## PIC16(L)F18854 Family Silicon Errata and Data Sheet Clarification

The PIC16(L)F18854 family devices that you have received conform functionally to the current Device Data Sheet (DS40001826A), except for the anomalies described in this document.

## Data Sheet Clarifications

The following typographic corrections and clarifications are to be noted for the latest version of the device data sheet (DS40001826A):

**FIGURE 32-14: TIME OF FLIGHT MODE REPEAT ACQUISITION TIMING DIAGRAM**

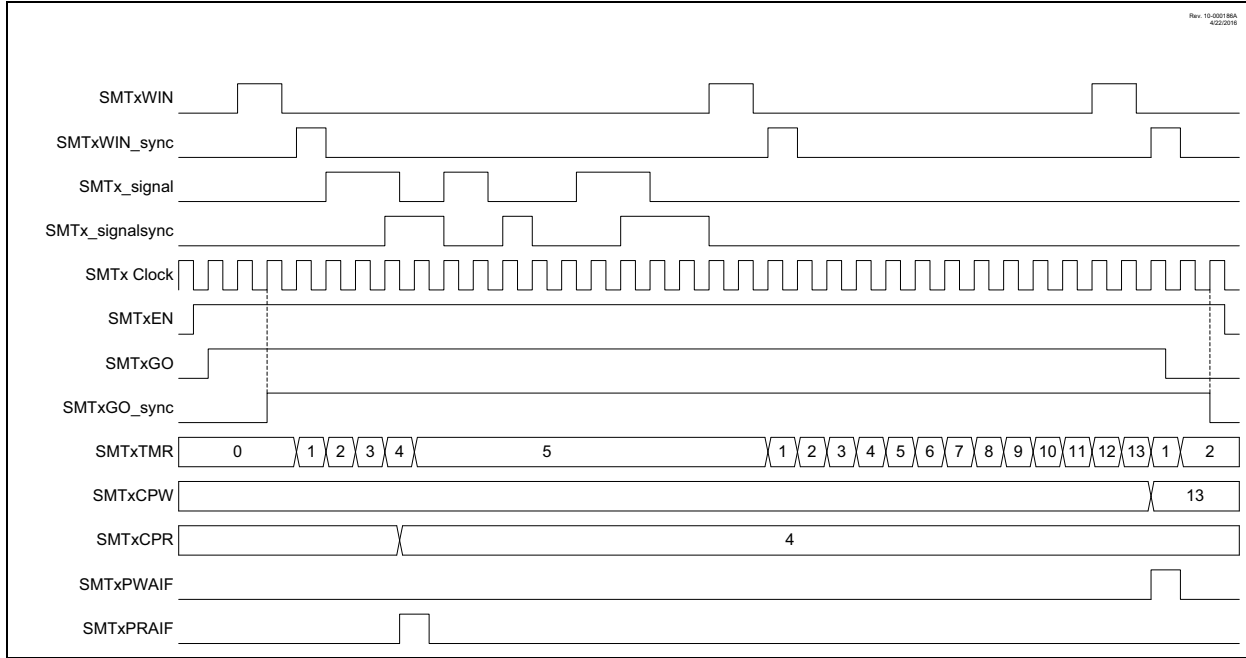
Several timing diagrams in the Signal Measurement Timer chapter (namely Figures 32-14, 32-15, and 32-18) contain inaccuracies. The correct versions of these timing diagrams are below.

**FIGURE 29-3: TIMER2 PRESCALER POSTSCALER, AND INTERRUPT TIMING DIAGRAM**

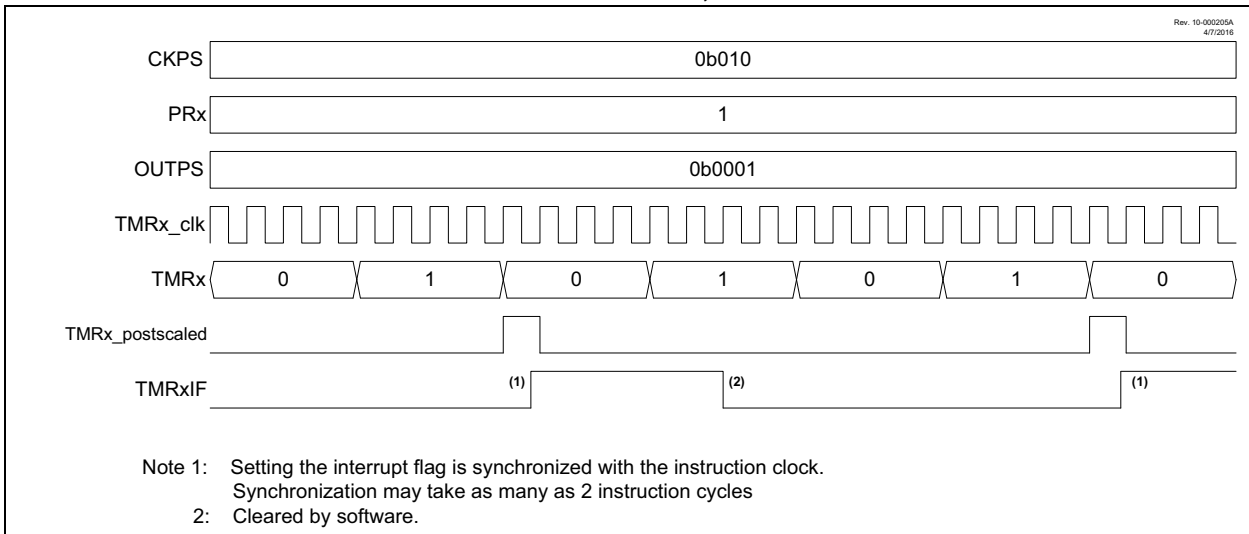
Several timing diagrams in the Timer2/4/6 chapter (namely [Figure 29-3](#), as well as [Figures 29-8](#) through [29-13](#)) contain inaccuracies. The correct timing diagrams are shown below.

**FIGURE 28-1: TIMER1**

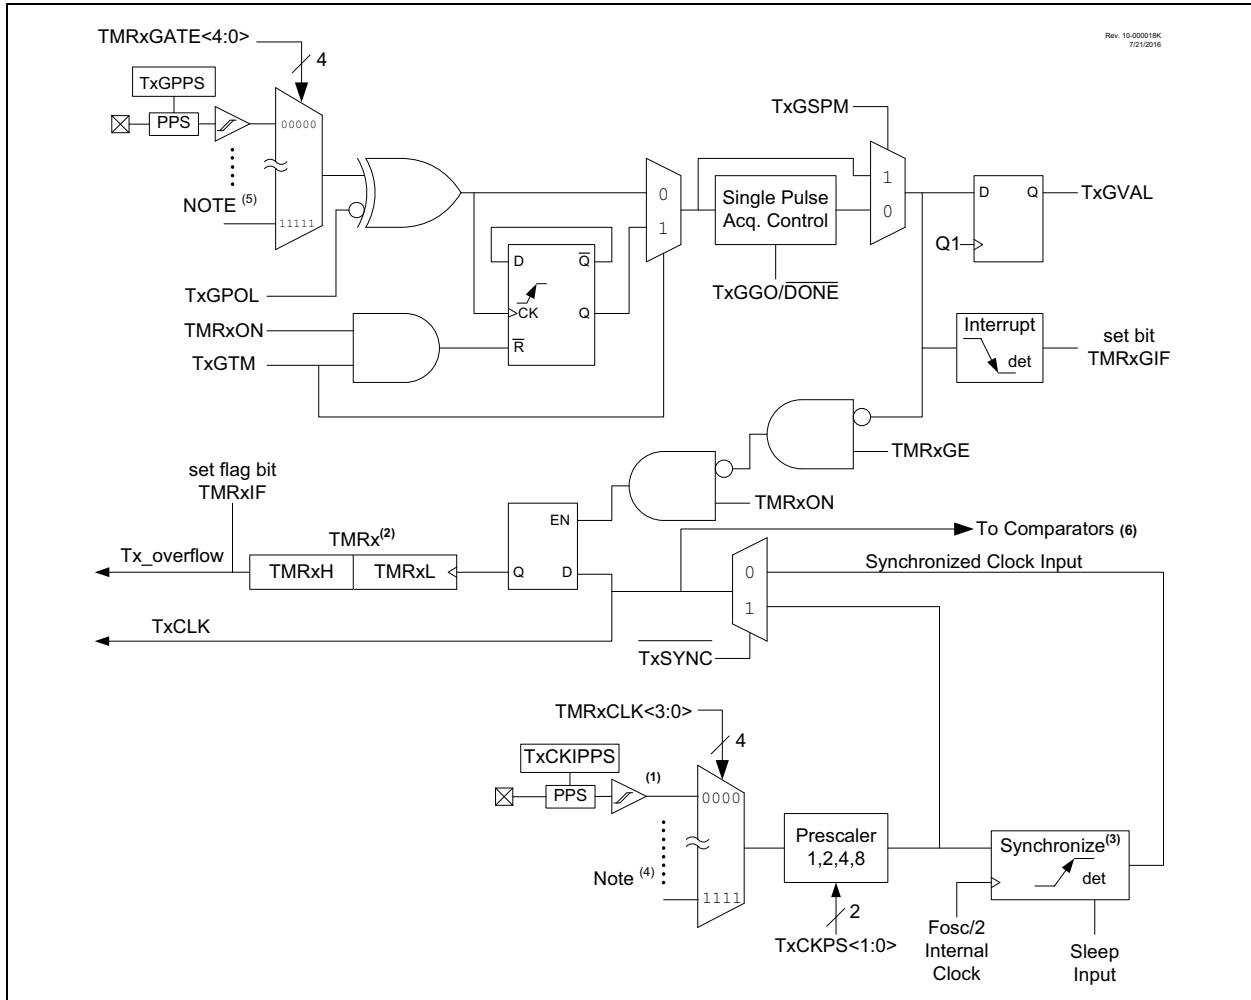
Figure 28-1 is incorrect. The correct diagram is below:

FIGURE 23-2: ANALOG-TO-DIGITAL CONVERTER WITH COMPUTATION (ADC<sup>2</sup>)

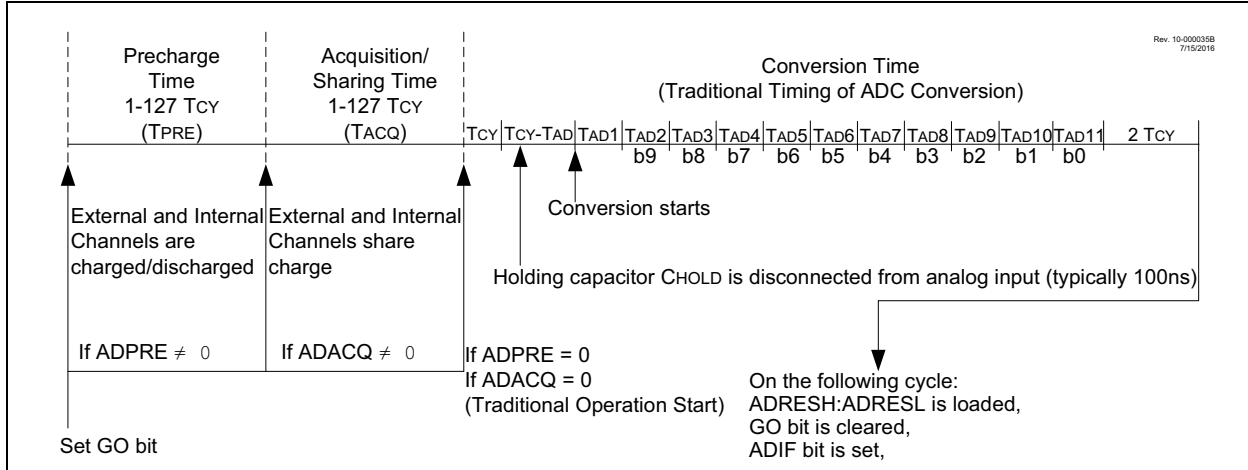
Figure 23-2: Analog-to-Digital Converter with Computation (ADC<sup>2</sup>) is inaccurately described in the data sheet for the ADCC. It should be as follows:
